WELL API NO. 30-025-24414
5. Indicate Type of Lease STATE X FEE
6. State Oil & Gas Lease No.
7. Lease Name or Unit Agreement Name STATE "2"
8. Well Number 002
9. OGRID Number 215099
10. Pool name or Wildcat ANTELOPE RIDGE; ATOKA (GAS)

SUNDRY NOTICES AND REPORTS ON WELLS
(DO NOT USE THIS FORM FOR PROPOSALS TO DRILL OR TO DEEPEN OR PLUG BACK TO A DIFFERENT RESERVOIR. USE "APPLICATION FOR PERMIT" (FORM C-101) FOR SUCH PROPOSALS.)

2. Name of Operator
CIMAREX ENERGY COMPANY

**CONDITIONS OF APPROVAL
FOR PLUGGING AND ABANDONMENT
OCD - Southern District**

State 22

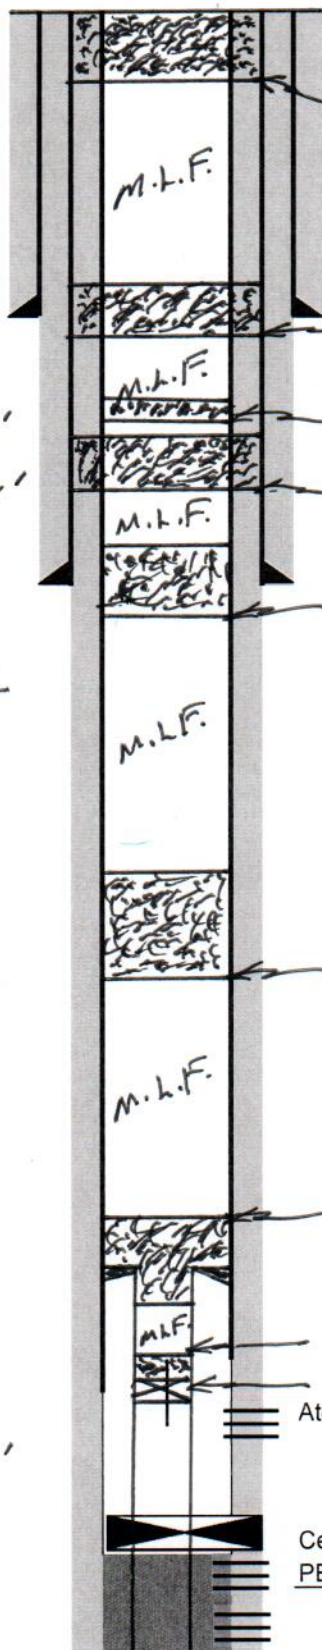
4" diameter 4' tall above ground marker

See Attached
Conditions of Approval
